# 16 Avenue Widening

Stakeholder Report Back: What we Heard

November, 2018

### Option A – Street level crossing (at-grade)

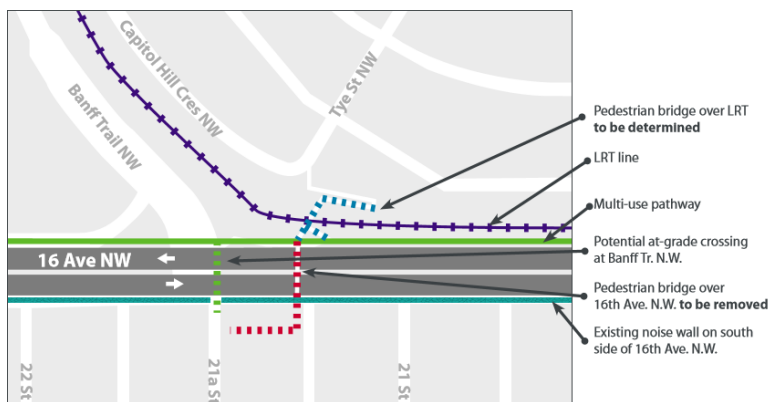
What are the issues? (Option A – Street level crossing (at-grade))

<p>Themes for comments provided for 'Issues'</p>
<ul style="list-style-type: none"> <li>• Concern for safety and perception of danger with any grade crossing location</li> <li>• General lack of support for Option A</li> <li>• Concern any at grade crossing along 16 Avenue N.W. has negative effect on traffic flow increases congestion</li> <li>• Concern an at grade crossing will require a break in the sound wall along 16 Avenue which is a major cause of concern for adjacent residents</li> <li>• Concern at grade crossings are not accessible and will have associated mobility challenges</li> <li>• General support for Option B</li> <li>• Concern for increased noise pollution with Option A</li> <li>• Concern for increase pollution in the surrounding neighbourhoods as a result of idling cars</li> </ul>

What are the opportunities? (Option A – Street level crossing (at-grade))

<p>Themes for comments provided for 'Opportunities'</p>
<ul style="list-style-type: none"> <li>• Removal of overpass could increase adjacent residents privacy as citizens would no longer be able to view into private properties</li> <li>• Opportunity to reduce speed limit at project area on 16 Avenue N.W.</li> <li>• Generally speaking there were very few comments that provided input on opportunities for Option A and most input collected was opposed to Option A</li> </ul>

## Option B – Overhead crossing (keep existing pedestrian bridge)

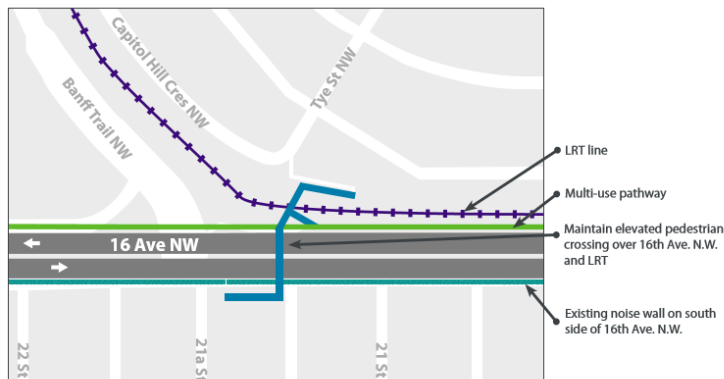
What are the issues? (Option B – Overhead crossing)

<p>Themes for comments provided for 'Issues'</p>
<ul style="list-style-type: none"> <li>• Concern for current lack of integrated connections with overpass</li> </ul>

What are the opportunities? (Option B – Overhead crossing)

| <ul style="list-style-type: none"><li>• Uphold a safe pedestrian passage in the area by proceeding with Option B</li><li>• Opportunity to increase lighting on the overpass</li><li>• Opportunity to not disrupt traffic flow along 16 Avenue N.W.</li><li>• Opportunity for upgrades that increase mobility and accessibility for citizens walking and cycling</li></ul> |
